AGENDA December 6th, 2011 at 3:00 pm

PLANNING & ZONING BOARD/SPECIAL MAGISTRATE

Re: *Turkey Run-Providence ILF; 3rd Plan Review*
City of Wildwood, Florida
City Project Number SP1103-03
KHA Project Number 142173056

On behalf of the City of Wildwood, Kimley-Horn and Associates, Inc. has reviewed the plans by American Civil Engineering Company dated November 1, 2011 and has the following comments:

ILF SITE PLAN
**PROVIDENCE
INDEPENDENCE COMMUNITY
AT TURKEY RUN PUD**
WILWOOD, FLORIDA

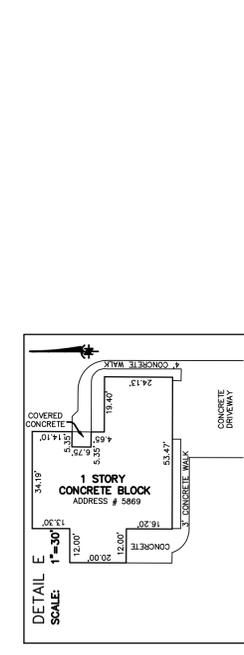
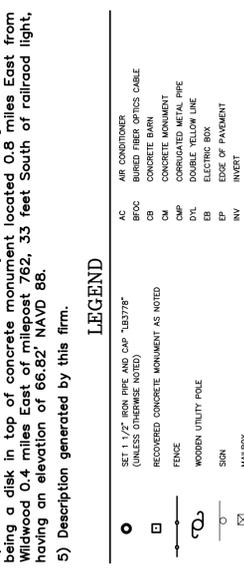
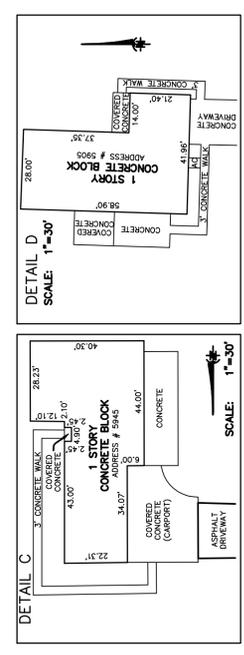
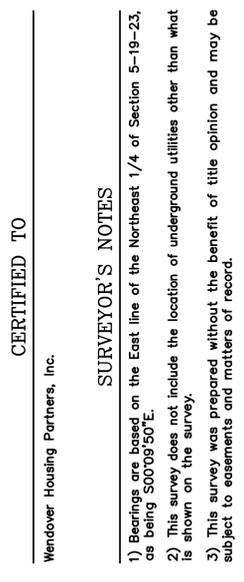
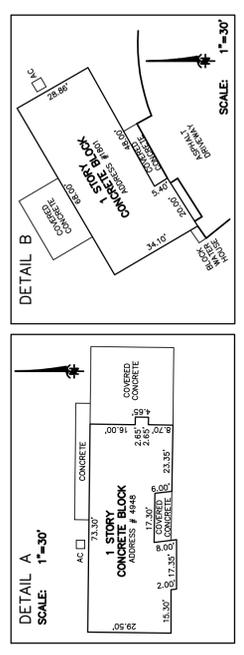
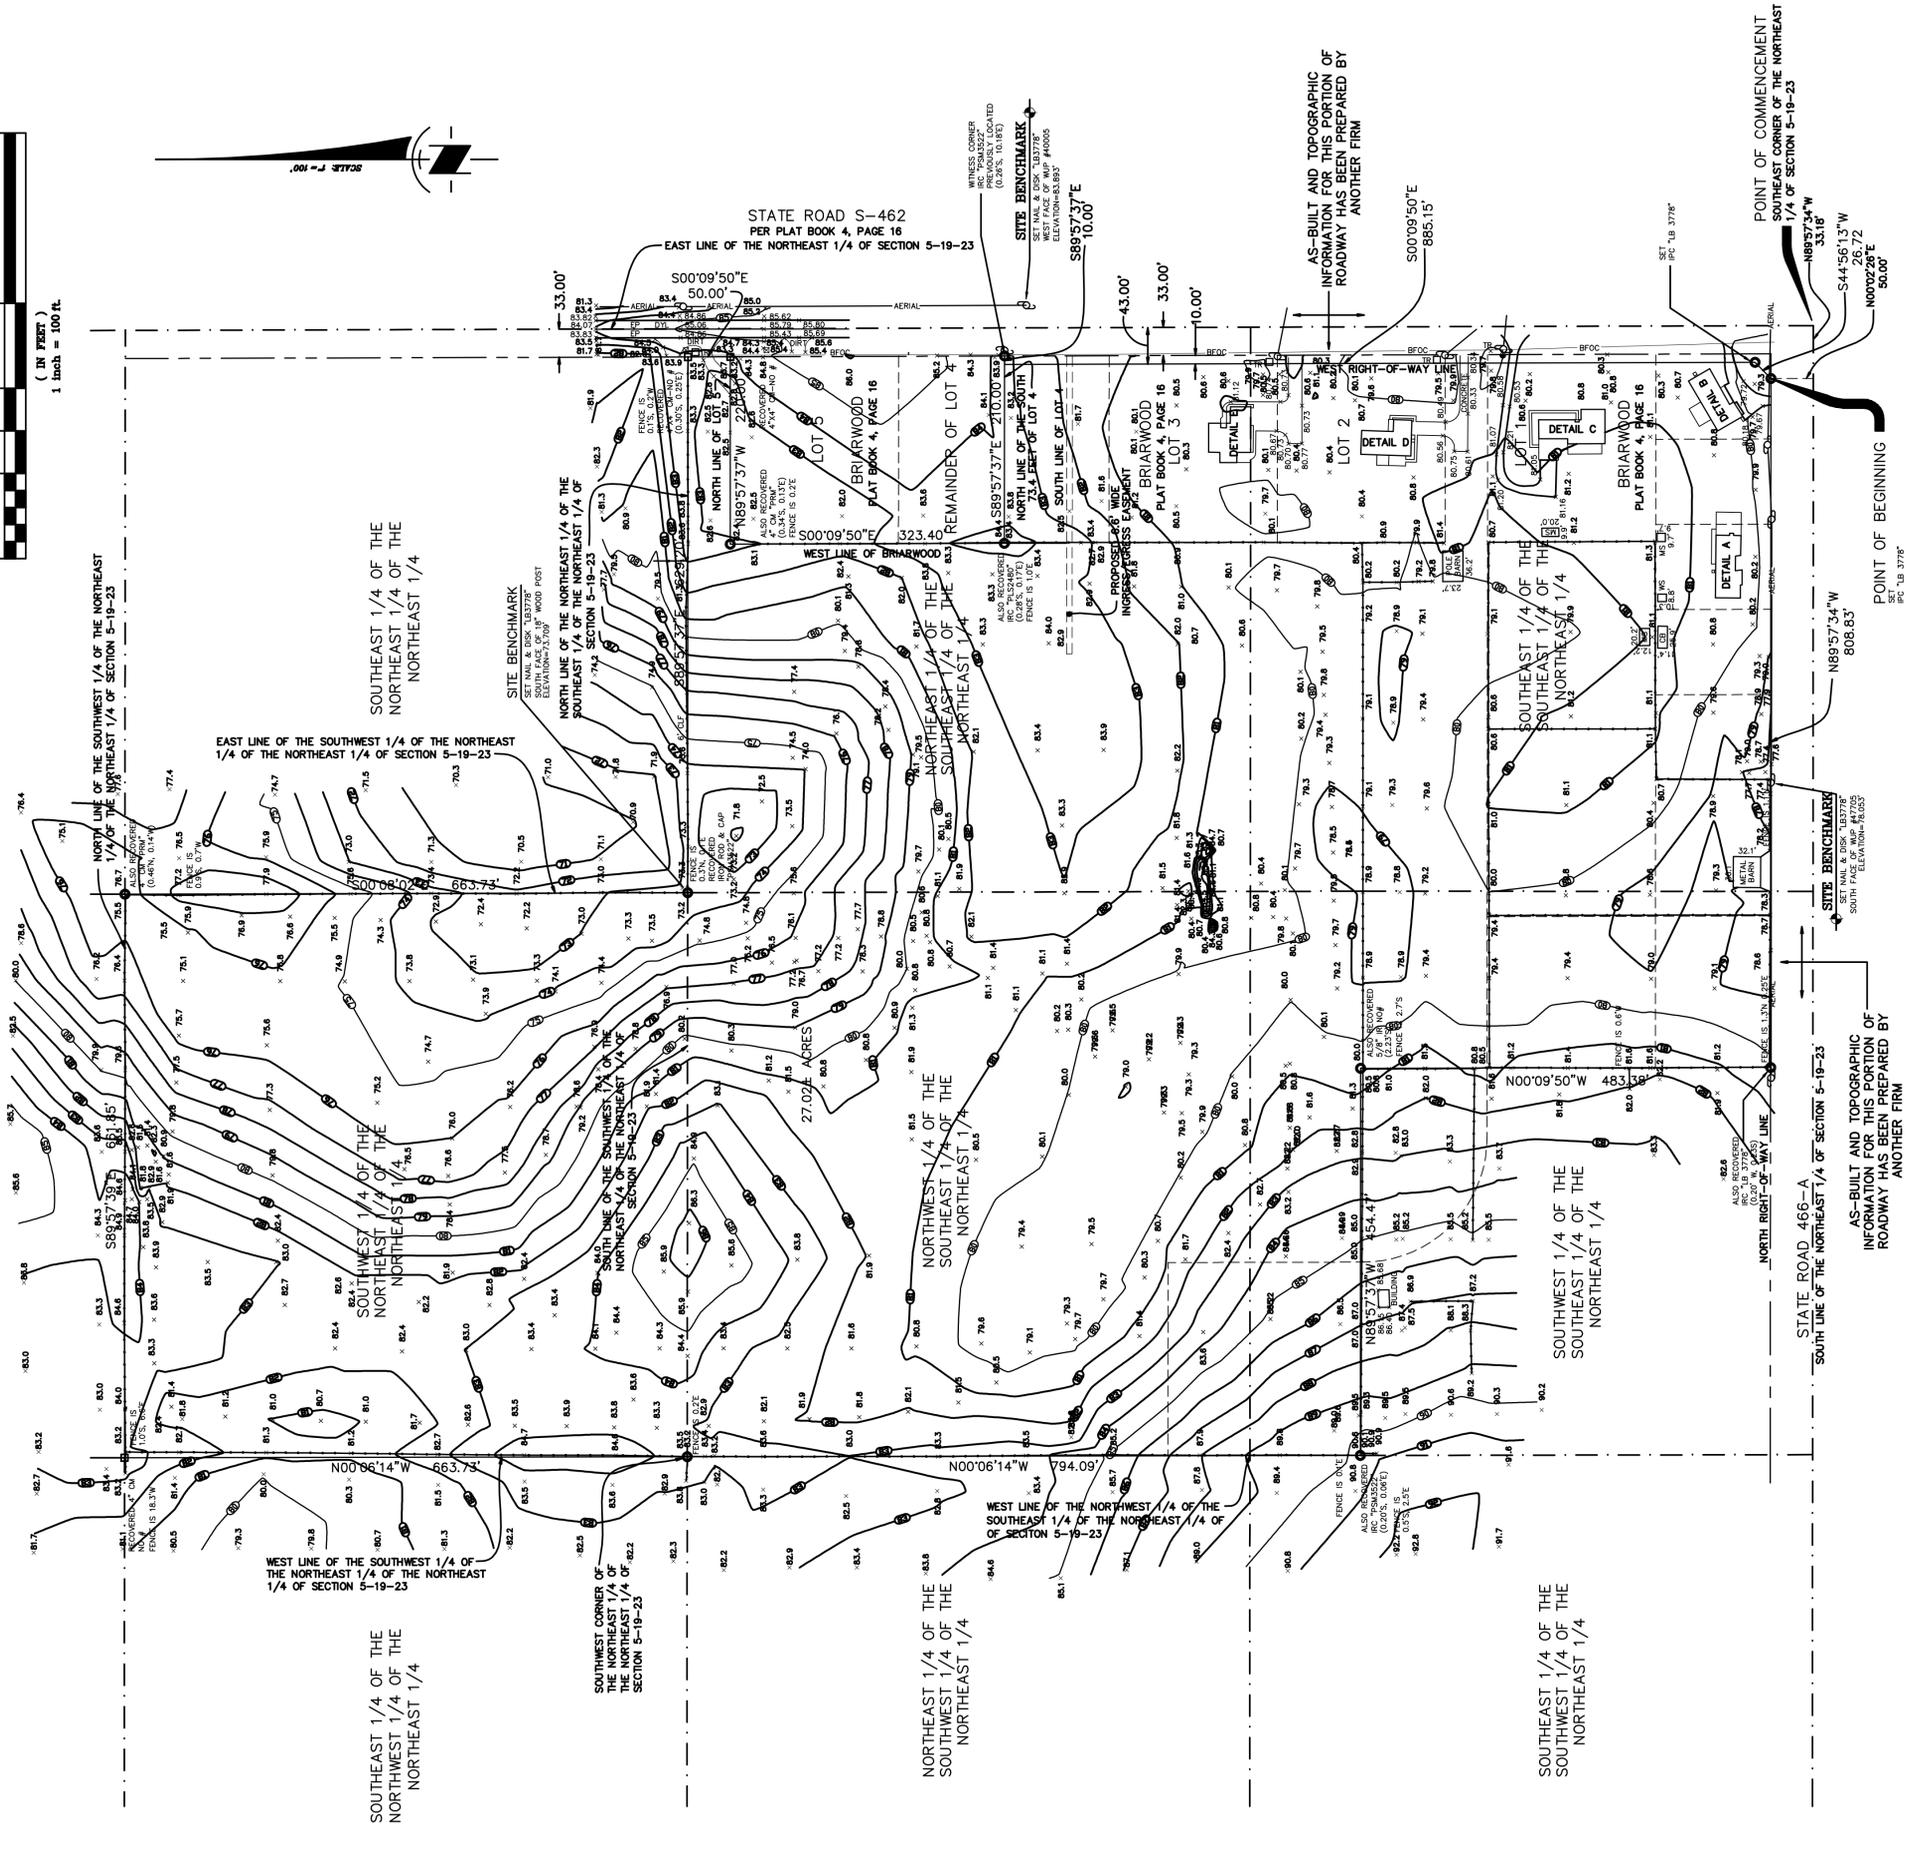
1. The environmental assessment mentions active gopher tortoise burrows on the site. Show the locations of the active burrows on the plans. If any burrows will be disturbed during construction, provide a copy of the relocation permit from the FWC for the impacted burrows.

3. Extend the sidewalk on C-462 north to the 52' right-of-way road. The sidewalk adjacent to C-466A should be 8' per the Developer's Agreement. A 5' sidewalk will require a change to the Developer's Agreement. Be advised, Sumter County is planning to build the 8' sidewalk with their C-466A road widening project.

6. Provide assurance that the basin calculations and conveyance calculations include the future 52' right-of-way, in particular, the portion west of the North/South Access Road that the City may construct in the future. The City should not be responsible for any future DRA expansions or pipe upsizing in the future.
7. Provide knockouts on the storm structures in the 52' right-of-way road to be used for future drainage connections. Depending on the drainage calculations, if larger pipes are need to accommodate the future 52' roadway, these structures may need to be constructed with 'J' bottoms.
8. Provide a letter of approval from Sumter County for all drainage improvements in the C-466A right-of-way.
9. Change the plan note to "Remove and reconstruct" the Type 'F' curb.

10. The vertical curve at STA 11+00 does not meet the required length for a design speed of 30 mph. Provide detail for the vertical curve including the K and A values, the start and end station and elevations, and the high point station and elevation.

11. A vertical curve is required at STA 15+50 for a design speed of 30 mph. Provide detail for the vertical curve including the K and A values, the start and end station and elevations, and the low point station and elevation.

12. Provide grading information at the edge of pavement on the paved aprons/roadway stub outs to aid in future road construction tie-ins.

13. It was noted in the responses that a revised hydraulic analysis will be provided after pressure test results are obtained. Please note, the utility plans cannot be approved until a complete analysis is re-submitted.

14. An FDOT Type-D inlet is not a traffic bearing drainage structure and should not be installed in areas of vehicular use without an H20 Load Rated frame and grate specified. FDOT Type-C inlets are also permissible if a proper frame and grate is specified.
15. Provide detailed grading information for lift station tract.

16. Provide a revised landscape plan for the new site layout.
17. Provide details for the landscape buffer surrounding the lift station including plant material, size, and quantities.

18. Revise the flow calculations to be consistent with Table 7-8 of the revised LDRs. Alternatively, provide source information for the ERU coefficients utilized in the calculations.
19. Revise the flow calculations to be 250 gpd/ERU for each use.
20. The float elevations do not match the elevations on the plans. Also, there should be a minimum of 6" between the influent invert and the high level alarm. The operating volume of the wet well should also provide for future flows from the west.

21. Provide soil borings within the limits of the retention pond that support the proposed pond design parameters.
22. Provide pre-post comparisons for all offsite nodes including Pre Node 30 and Post Node 31.

23. It was noted in the responses that grading will be performed in the area of Pre Weir 1. Provide information on the plans for this grading.
24. Provided justification for the selected weir discharge coefficients of 0.75.

25. It was noted in the responses that stormwater for the 52' right-of-way will be addressed in the design of Phase II. Provide assurance that the basin calculations and conveyance calculations include the future 52' right-of-way, in particular, the portion west of the North/South Access Road that the City may construct in the future. The City should not be responsible for any future DRA expansions or pipe upsizing in the future.

26. Conveyance calculations were not included in the revised drainage report. Provide calculations that use the 25-year tailwater elevation for all storm runs with structures located in the public right-of-way per LDR 6.5.(d)(1)(A).
